DEVELOPMENT REVIEW COMMITTEE (DRC) COMMENT REPORT

PROJECT NAME: Poinciana Crossing

CASE NUMBER: R19061

REQUEST: Site Plan Level II Review: 113 Affordable Residential Units in South Andrews - Regional Activity Center District

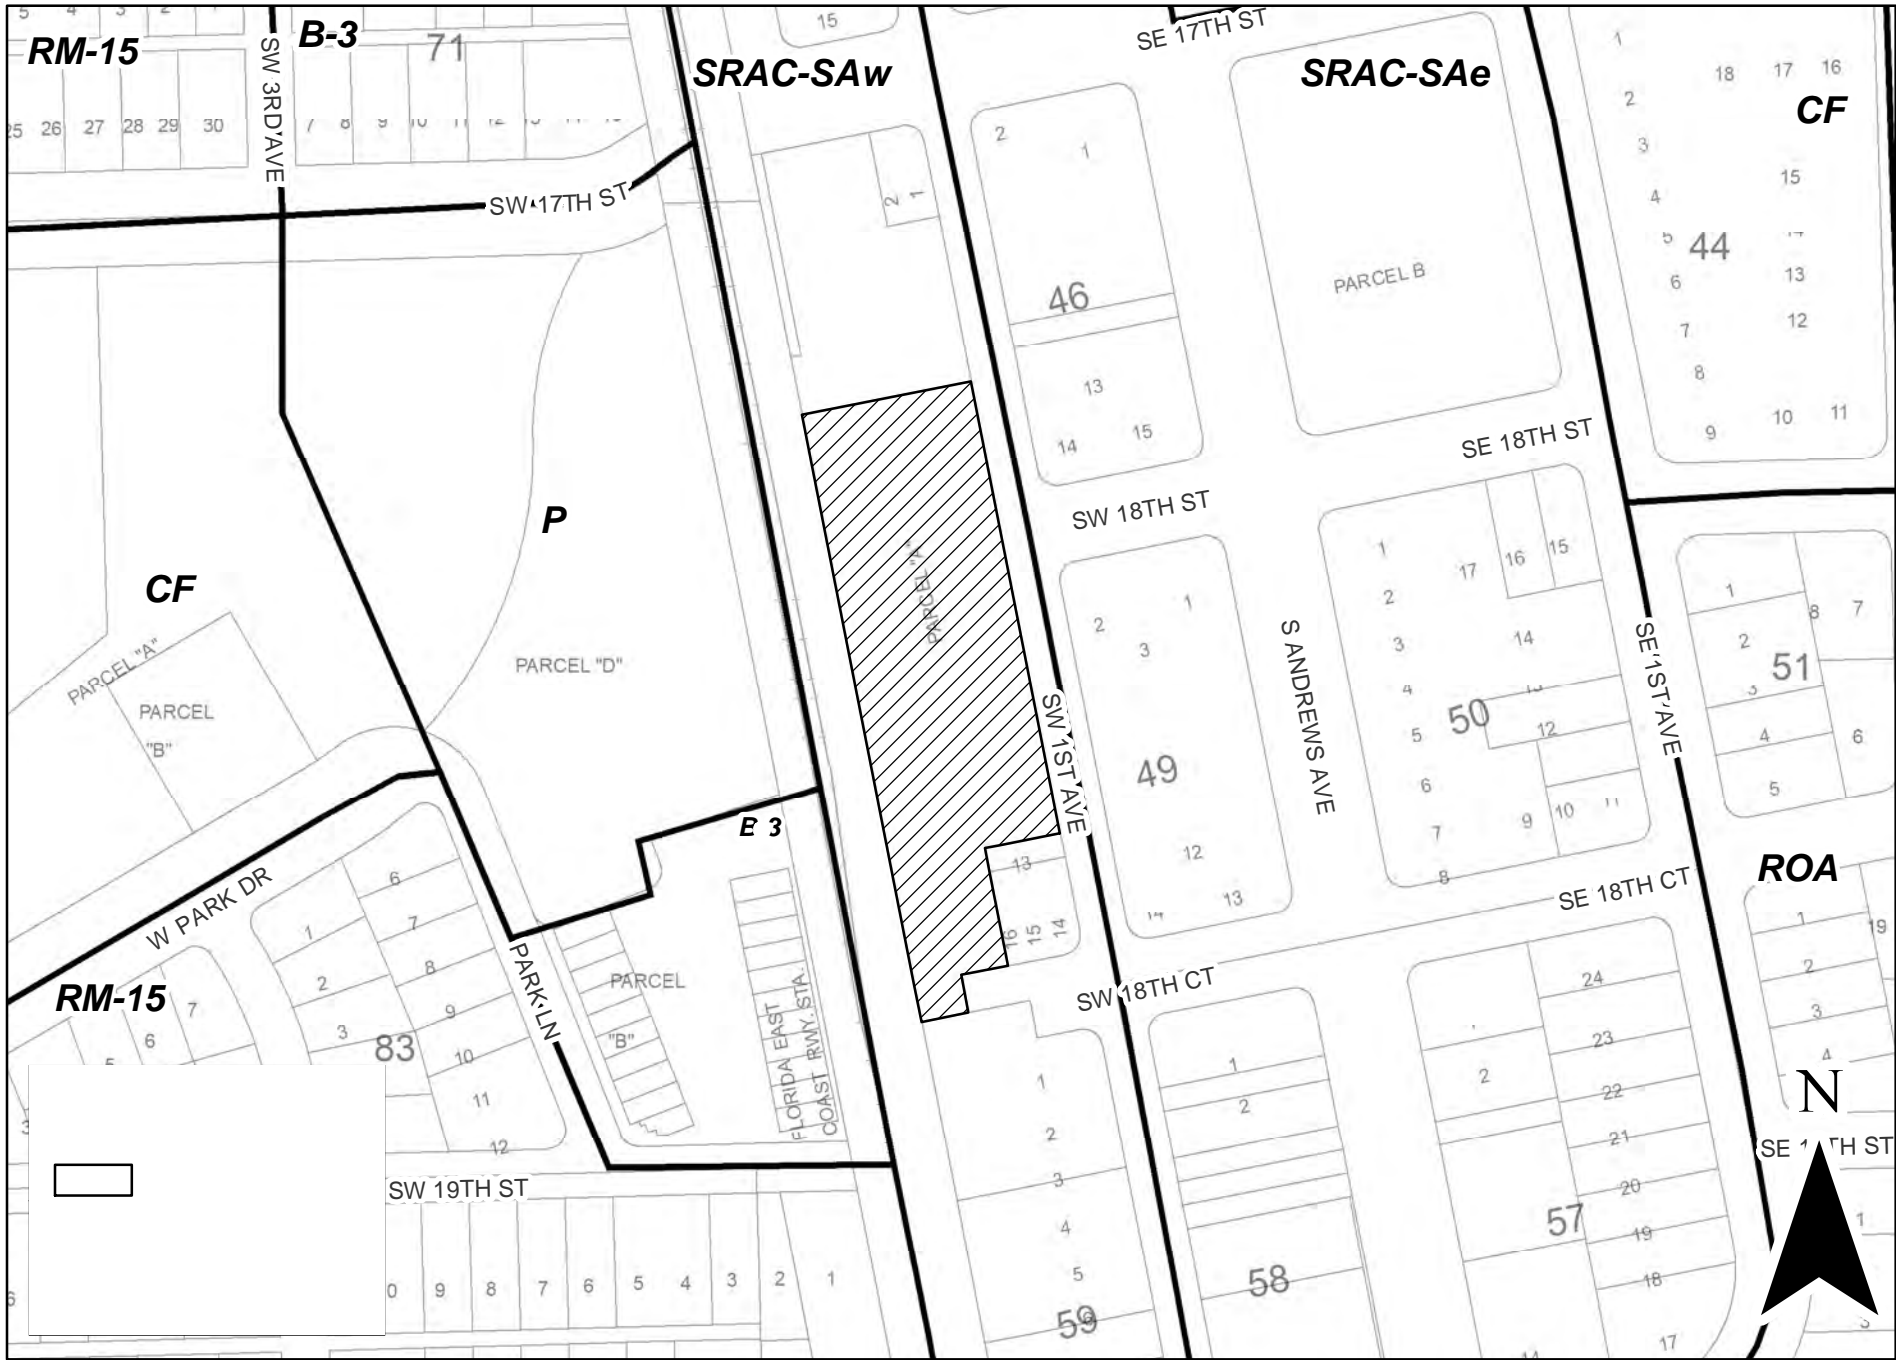
- d. Adjust setbacks to meet a minimum (5) foot build-to-line and a maximum (10) foot build-to-line.
 - e. Provide a straight sidewalk running parallel the SW 1st street with a clear path of at least 5 feet wide. Per the SRAC- SA Illustrations of Design Standards, the remaining portion of the right-of-way, from the

- curb of the parking space to the property line, plus the minimum five (5) feet building setback, shall be dedicated to the pedestrian realm, as outlined below:

- i. Large shade trees shall be located in a bulb-out, after every two parking spaces.
 - ii. Small shade trees or ornamental trees shall be located within the sidewalk, the trunk being a minimum of six (6) feet from the face of the building and spaced at the intersection of every parking space. Consult with Karl Lauridsen from Landscaping on tree type and specific location.
